CITY OF OPELIKA HISTORIC PRESERVATION COMMISSION

September 14, 2023

HISTORIC PRESERVATION COMMISSION MINUTES

**City of Opelika
Historic Preservation Commission
Staff Report**

Photos:

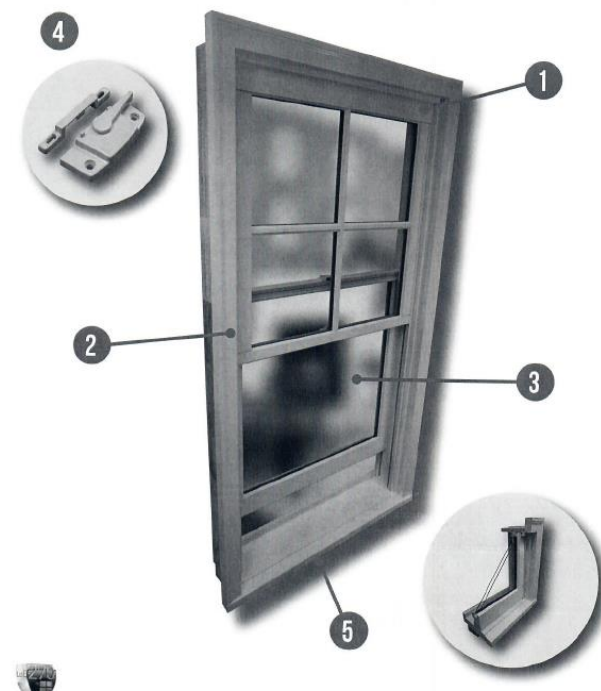
1. Replace all windows, except those previously approved on 2/09/23 which are to be converted into entryways, with Tucker Traditional Series 2100 wood windows with PVC brick mold and composite sill/sill nosing. Sashes and inside jamb are wood. Everything on the jamb that faces the outside is rot-proof (PVC).
2. Applicant to have exterior grills custom made to match existing grill pattern and request to not include grills on all rear (5) windows.

Window on rear with missing grill at bottom

- 1. Staff recommends approval of replacing windows with Tucker 2100 Series wood windows with no grills. Grills to be custom made and applied to match the existing grill pattern of each window.
- 2. The original number and arrangement of panes should be maintained.

Photo's:

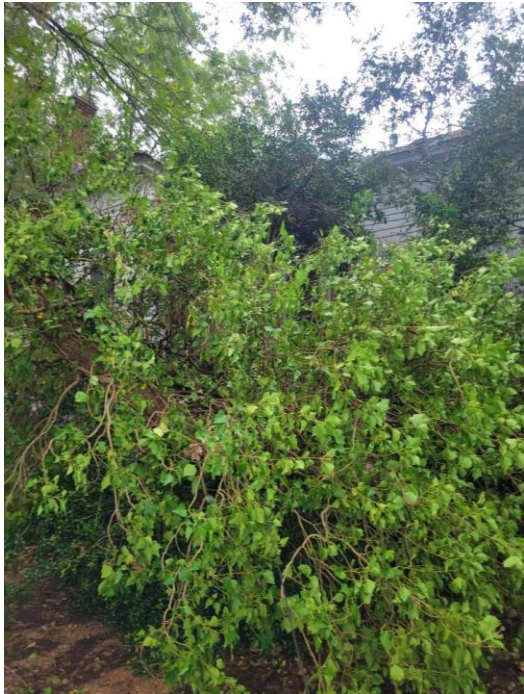
1. Cut chimney down to approximately three bricks, angle with roof line, and cap for weatherproofing due to tree damage during storm. Rebuilding chimney was not recommended by contractor due to difficulty in finding matching historic brick. Also, chimney is not visible from the street.

Close up view of damaged chimney

1. Staff recommends approval of cutting chimney down and capping. This will retain chimney location with nonworking fireplace.

Photo's:

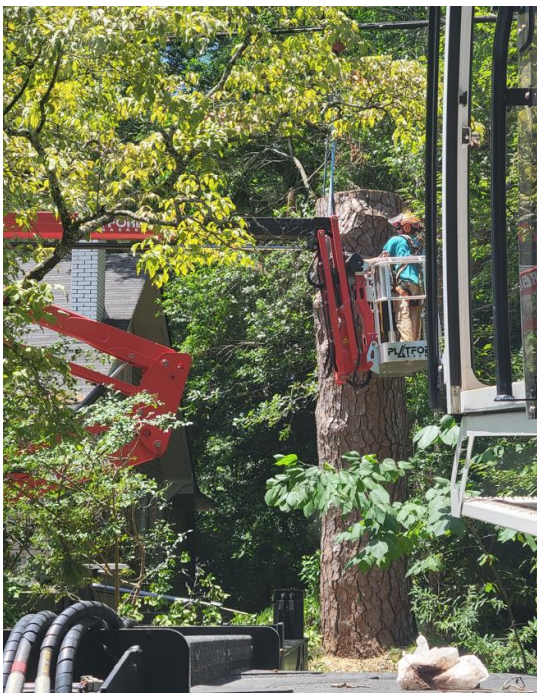
1. Retroactive COA for removing two trees. Limbs were breaking at increased rate damaging roof and causing leaks.

Top of tree already removed

1. Staff recommends approval of removing trees before damage is done to the structure based on its close proximity to the home.
2. Applicant must provide a tree replacement plan.

Photo's:

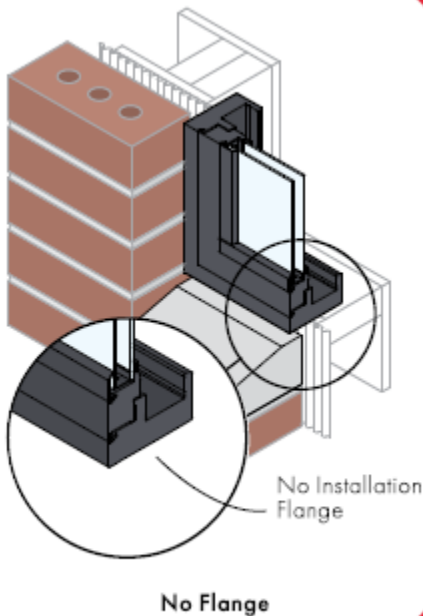
1. Replace upper floor windows with Anderson 100 Series Fibrex composite single-hung full divided light with $\frac{3}{4}$ " grill windows. Interior and exterior color will be white. Glass is Low-E non tinted.

- 1 Staff recommends approval of replacing upper windows with wood, composite, or aluminum clad windows with same grid pattern of 2/2. This type of window has not previously been used or approved by the Commission. Windows should appear to be wood or metal.

Photo's:

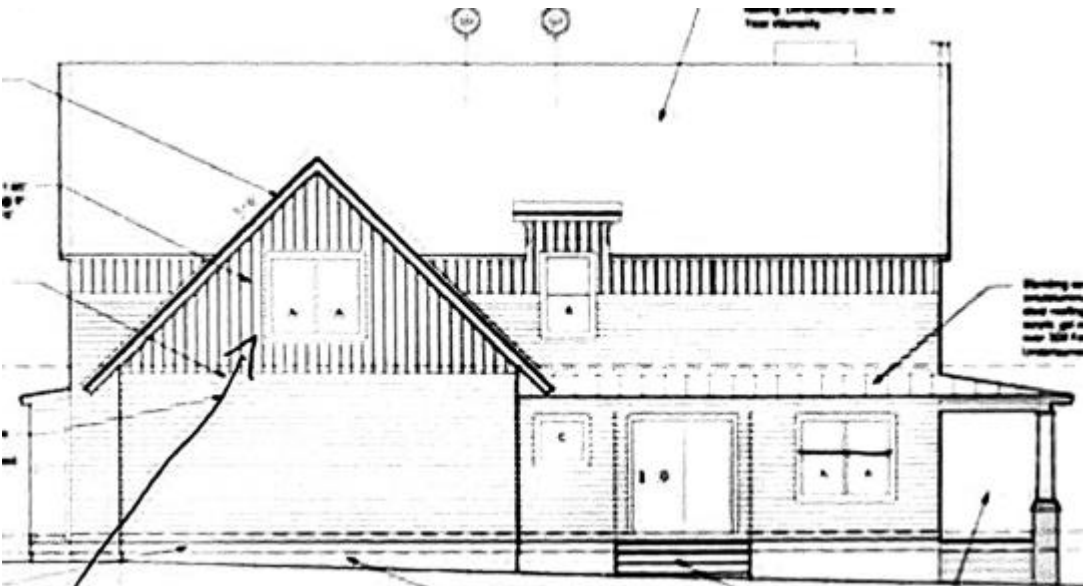
1. Install window on second floor above garage in rear of structure facing neighbor's house. The window is a Pinnacle wood clad white pushout style unit measuring 60" x 60". It is nearly identical to the double window on the same side of the house. A casement window will allow more light to enter the room, which is otherwise very dark due to its proximity to neighboring house.

Location above garage for proposed New window

1. Staff recommends approval of installation of new wood clad window to match existing windows.
